MARQUETTE CITY PLANNING COMMISSION
Tuesday, September 02, 2025, at 6:00 p.m.
Commission Chambers at City Hall – 300 W. Baraga Ave.

TO: Planning Commission
FROM: Andrea Landers, Zoning Official
DATE: August 28, 2025
SUBJECT: 07-SPR-09-25 (01-PUD-03-25) – Final Site Plan Review for W. Magnetic St
(Portion of PIN: 0410681)

VERIDEA GROUP
MARQUETTE GENERAL HOSPITAL SITE RE-DEVELOPMENT

Sheet C-04.2

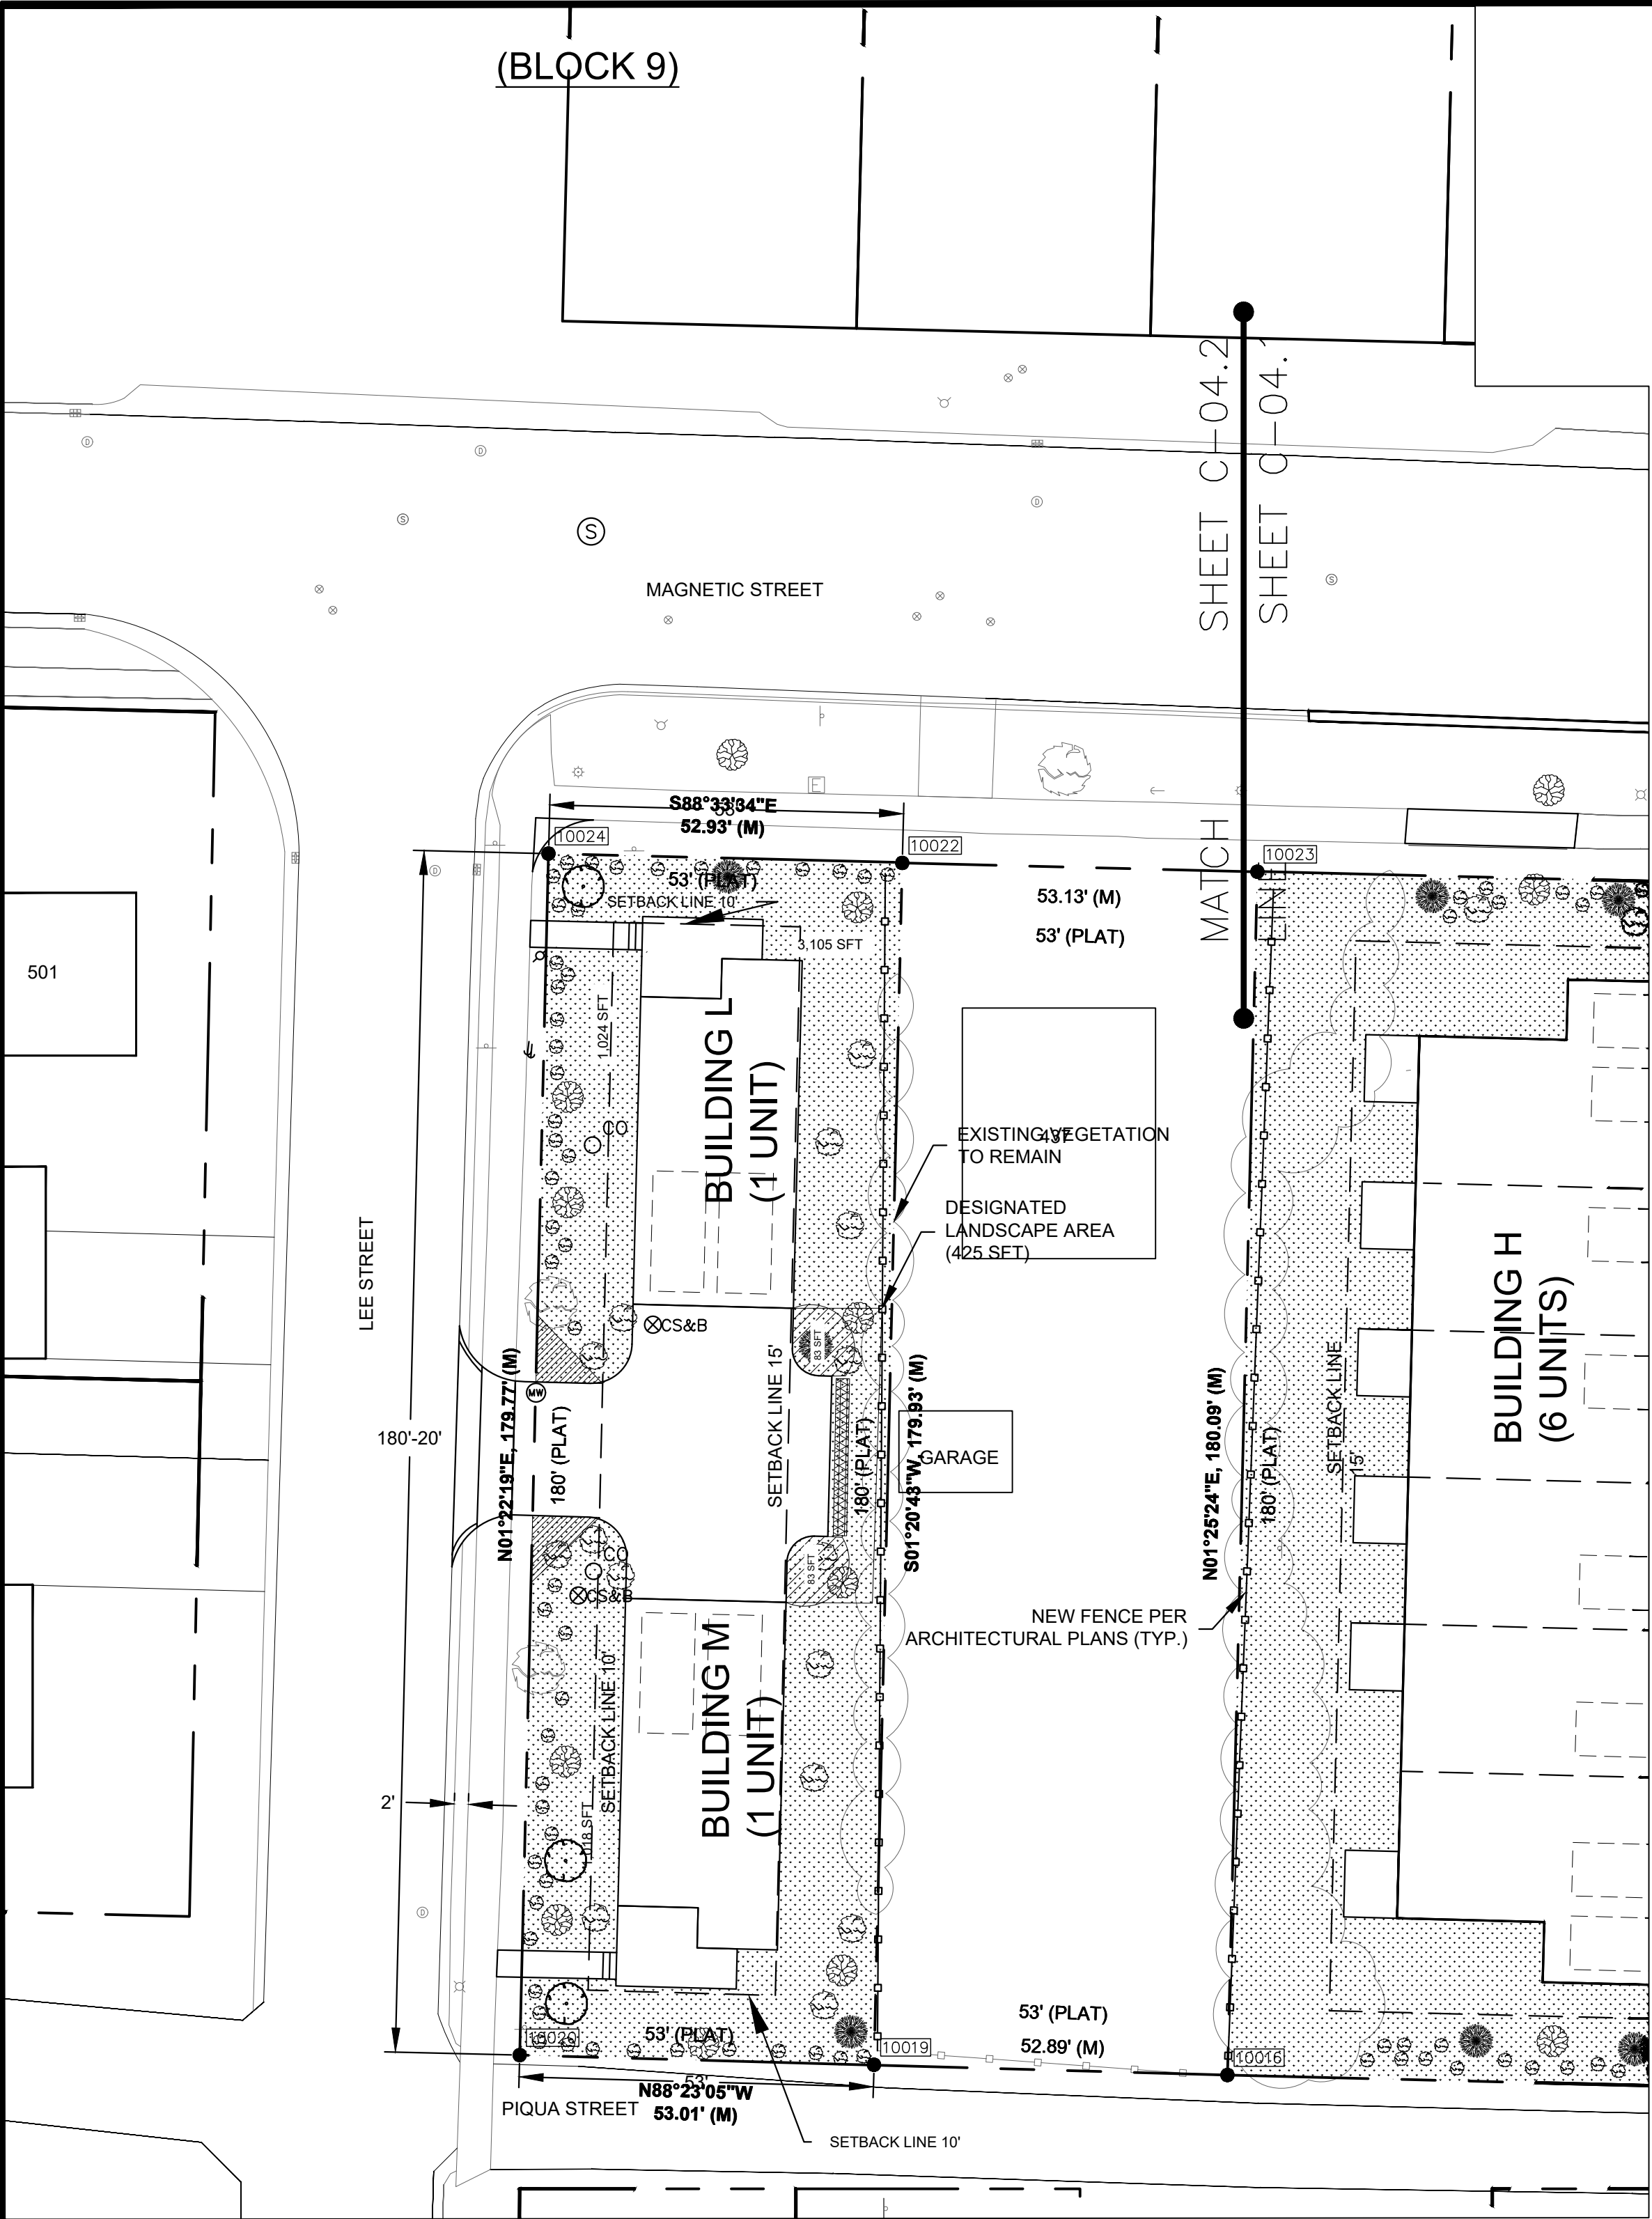
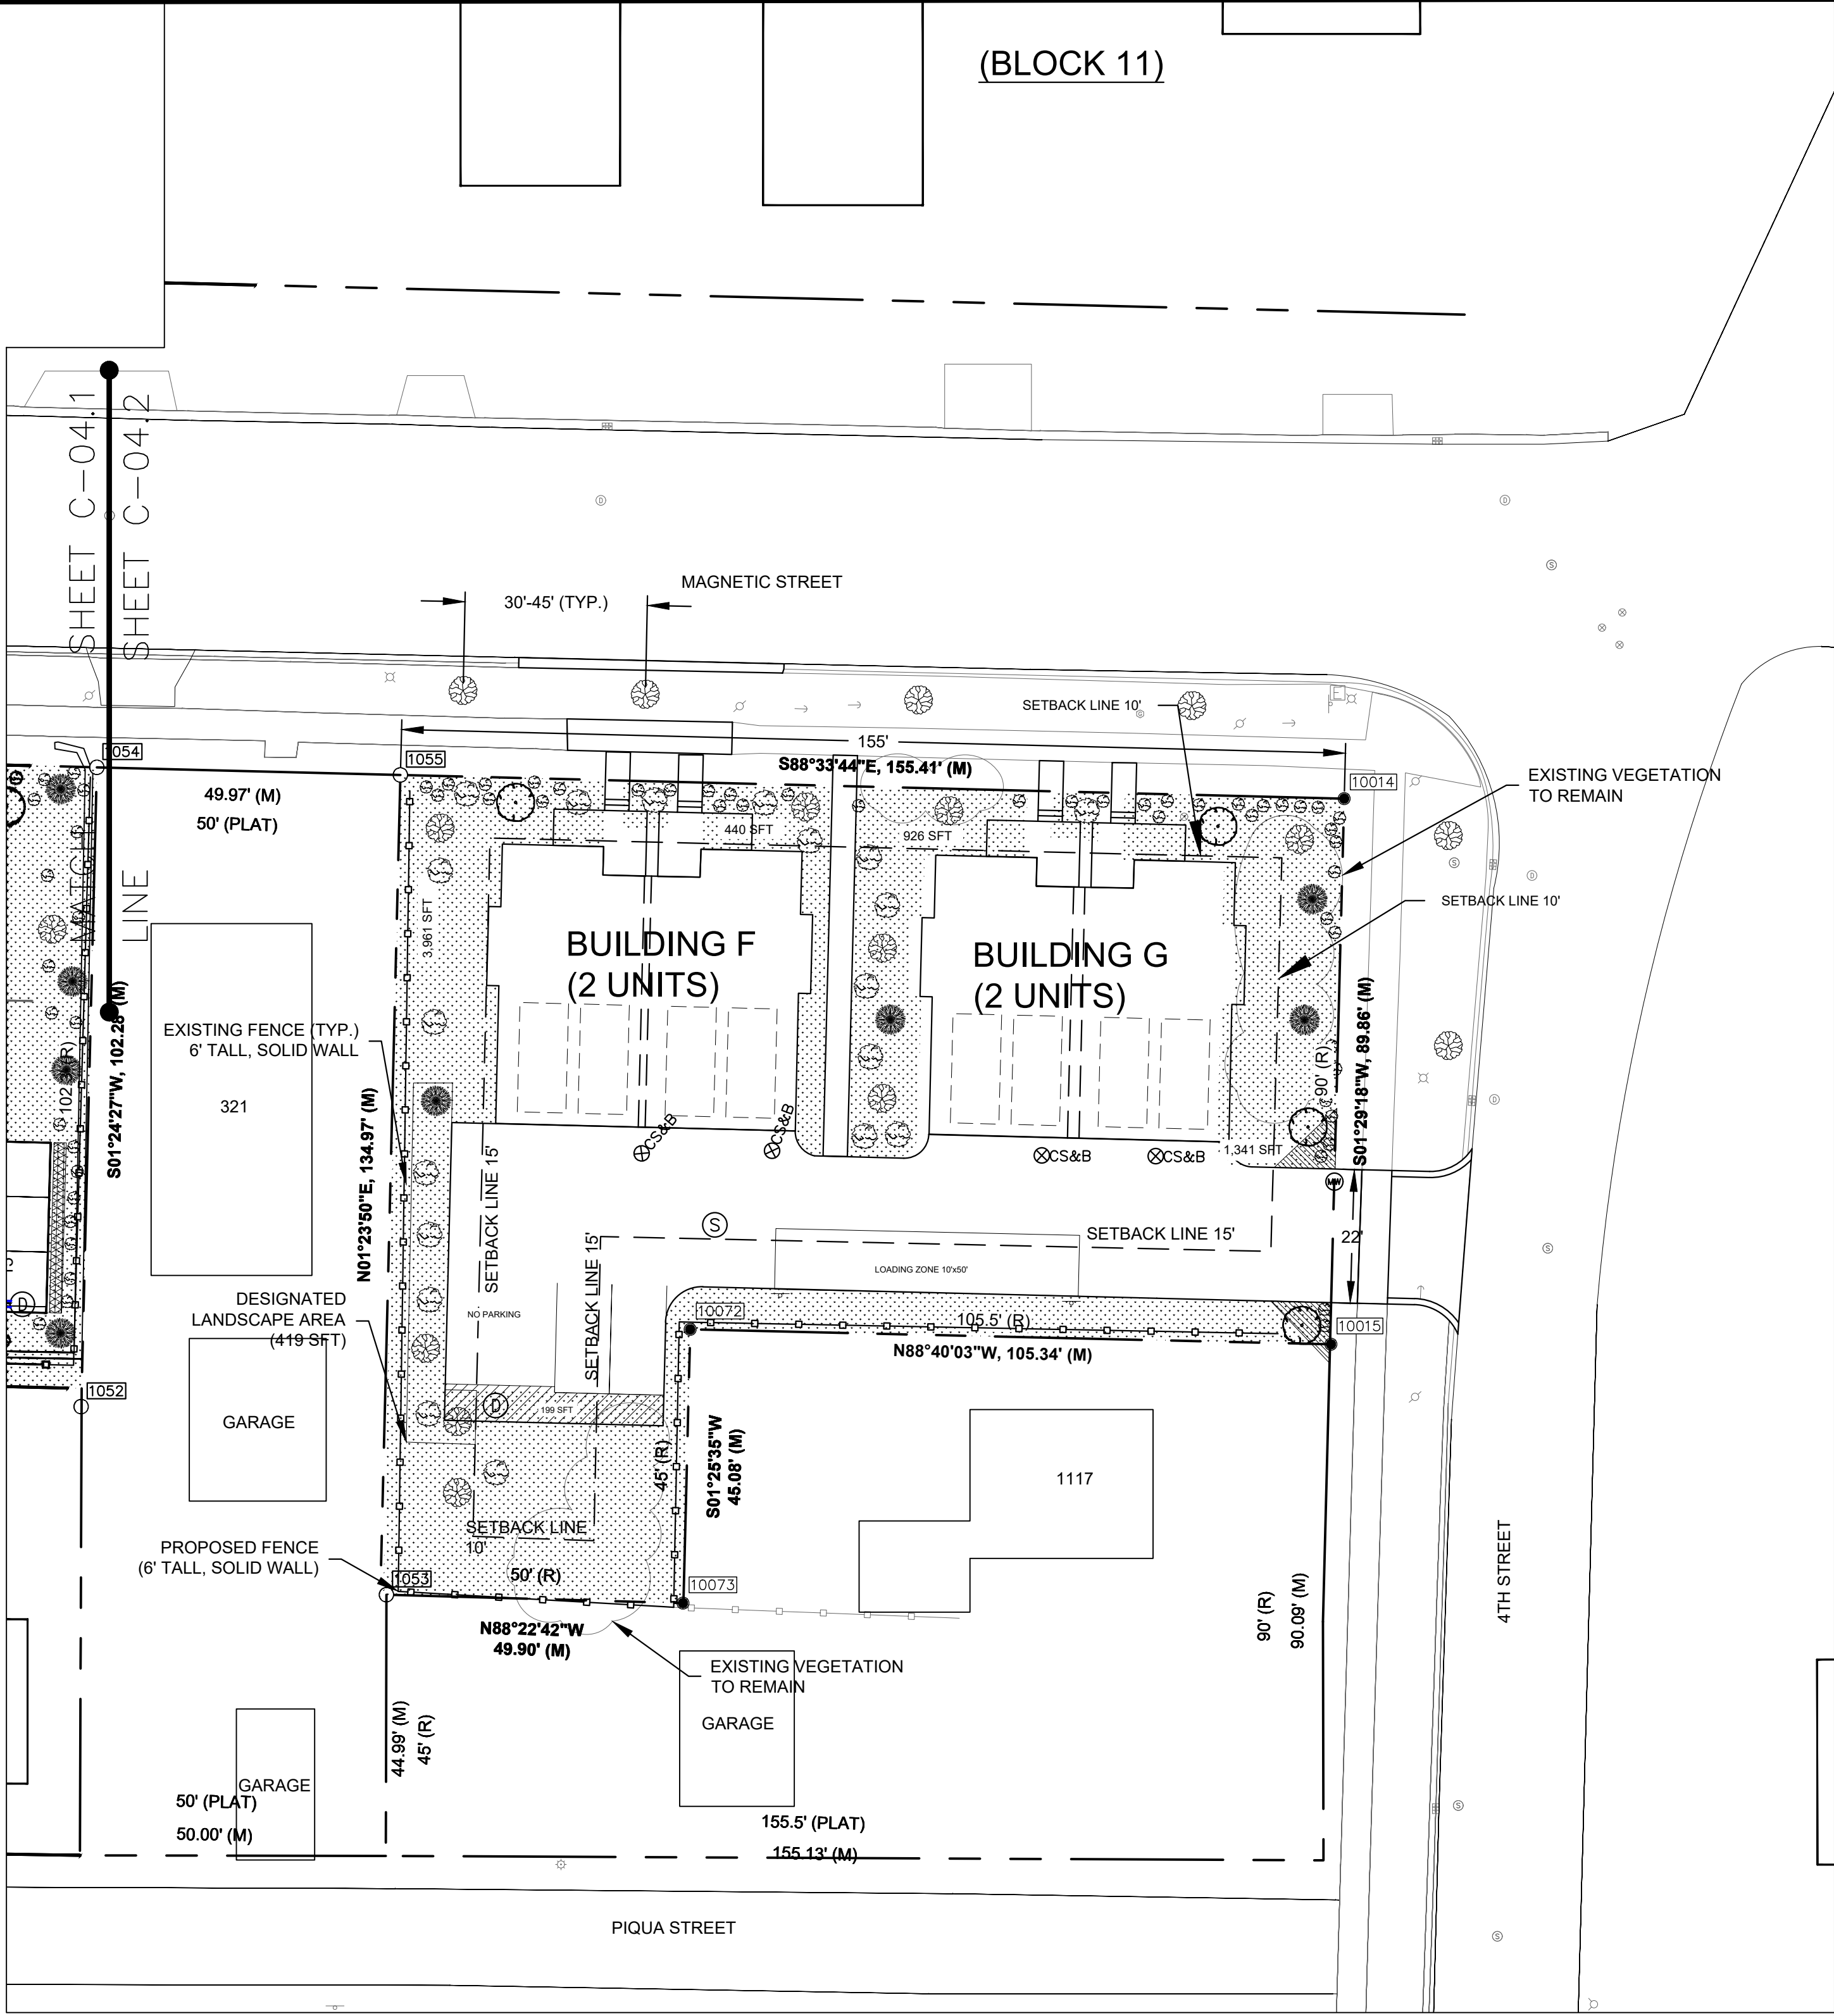
1. The parking lot to the south of Building F abuts a residential zoning district to the east, west, and to the south. Please provide how you propose to meet **Section 54.905(I)** of the LDC.
Plans will be revised to show fence height and type (6' height solid fencing). Existing fencing shall be removed and replaced in accordance with 54.905(I) and architectural sheet LP-100 and LP-101.
2. For Block 9 Lee Street Frontage. Missing 1 required Ornamental tree for a total of 2. Please provide.
Plans revised to add one more ornamental tree. (See sheet C-04.2).
3. For Block 11 interior parking lot landscaping, missing the 2 requires deciduous trees for the 419 S.F. area.
Plans revised to include 2 deciduous trees in the landscaping area. (See sheet C-04.2).

OVERALL SITE
LANDSCAPE PLANSHEET NO: **LP-100**

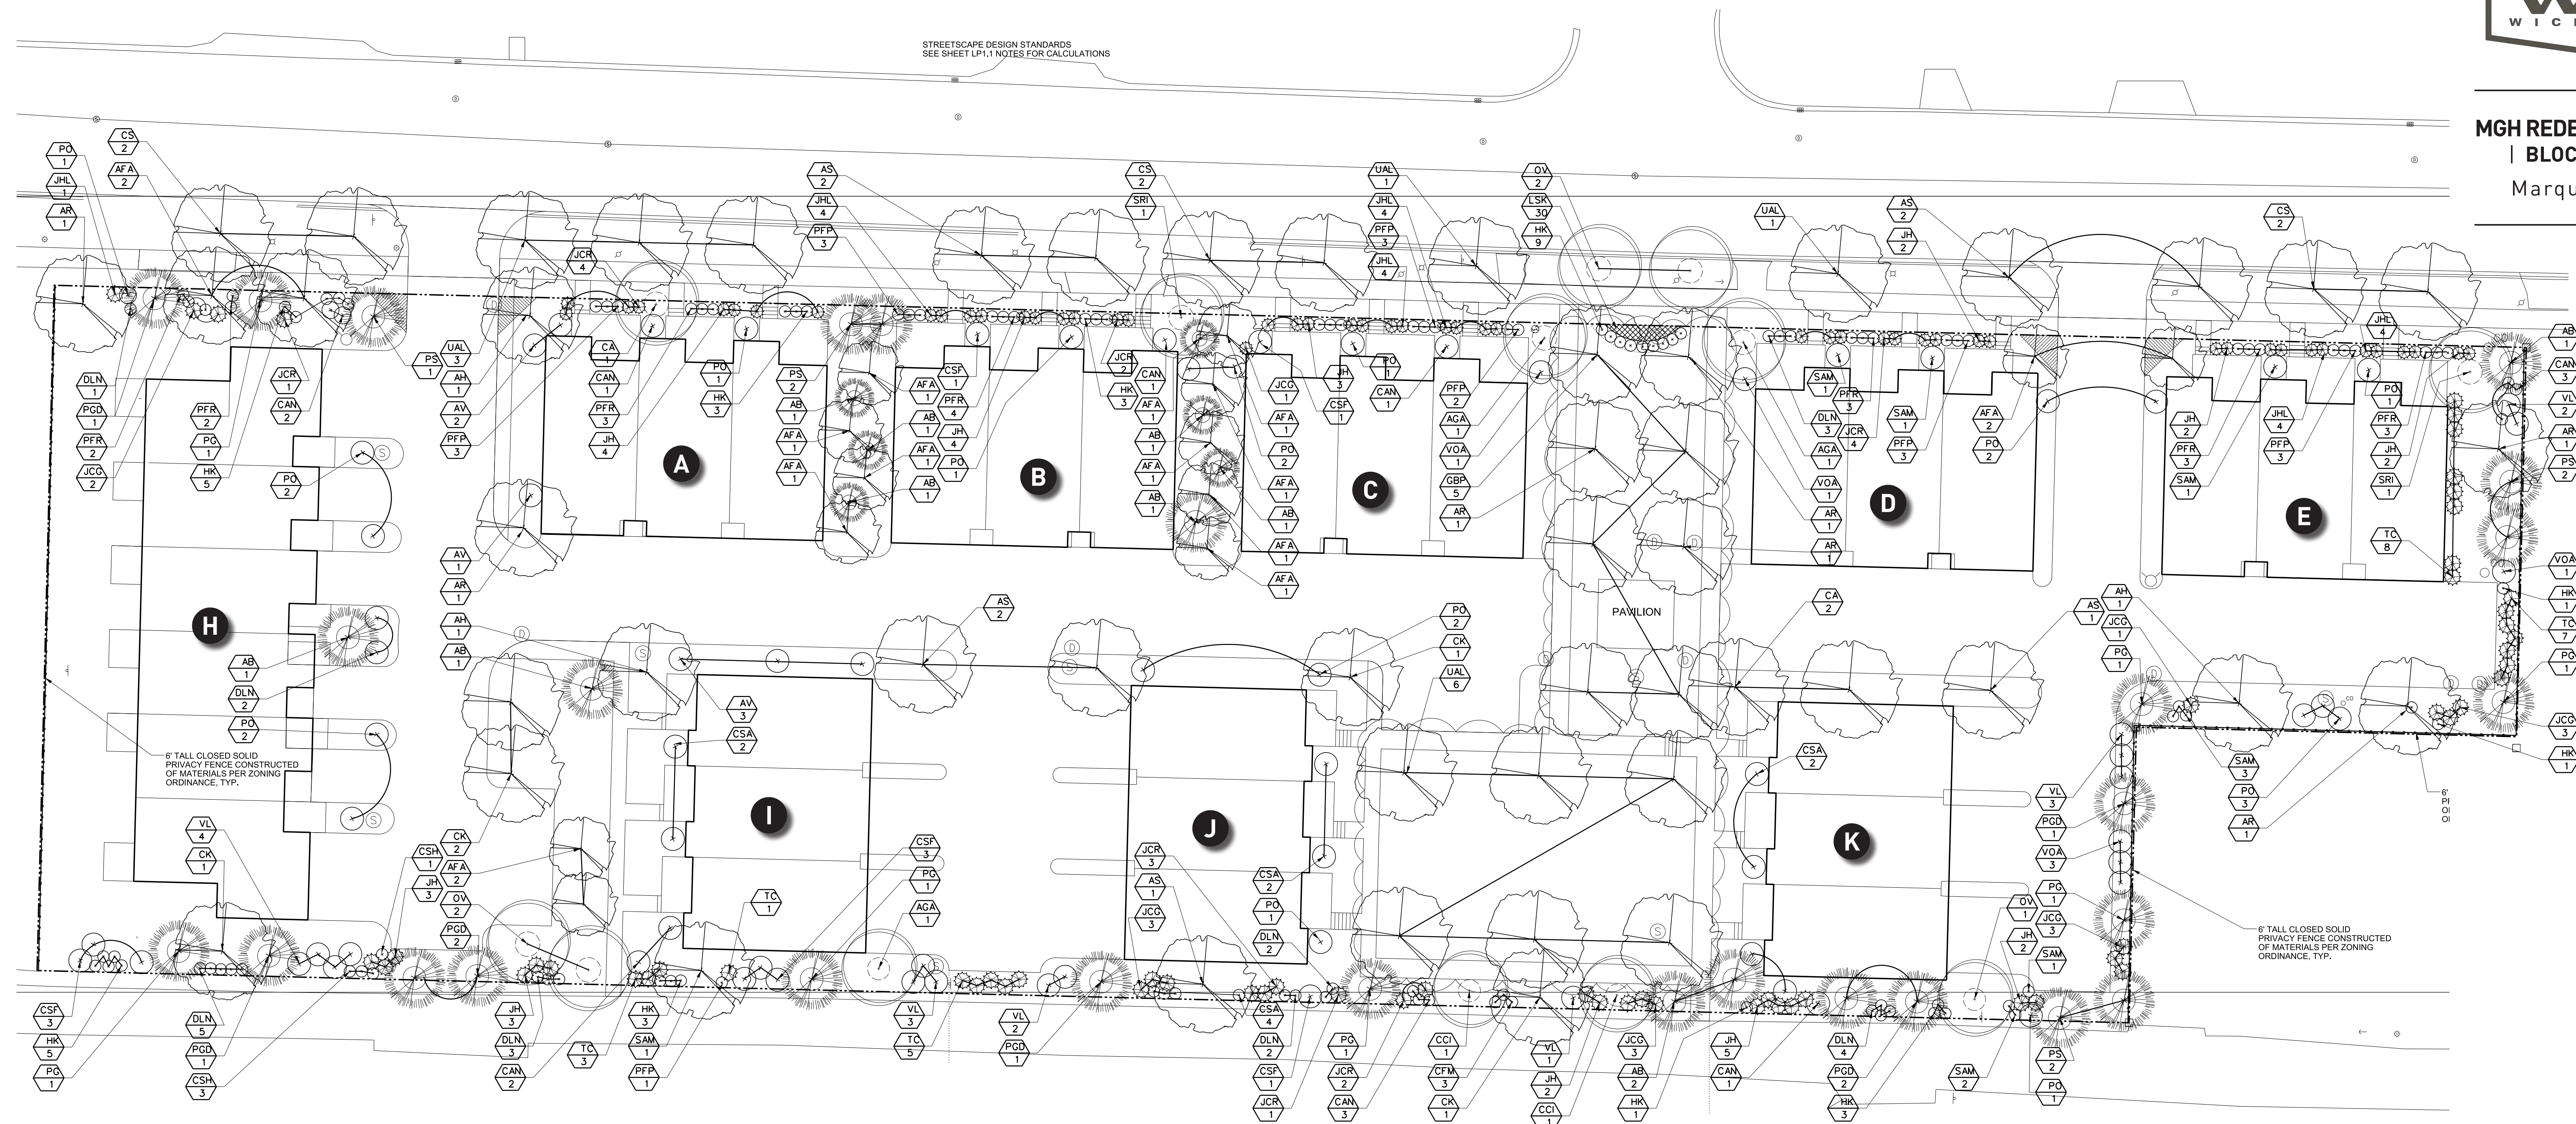
1. New sheets LP-100 and LP-101 have been added, but they do not match Sheets C-04.1 and C-04.2. Please revise the sheets to match the location and number of plants, and to meet the Land Development Code (LDC). **Sheets LP-100, and LP-101 will be made to match sheets C-04.1 and C-04.2.**
 - a. Please note, Horse Chestnut (nut bearing), Elm, Honeysuckles are on the prohibited list per Section 54.1004(C), please revise to meet the LDC. **Prohibited plans will be removed from the planting list and replaced with plant on the approved list in the LDC.**
2. If the lighting cut sheets are being used to provide the required lighting information, then it needs to be added to the site plan. **Cut sheets will be added to the site lighting plan.**
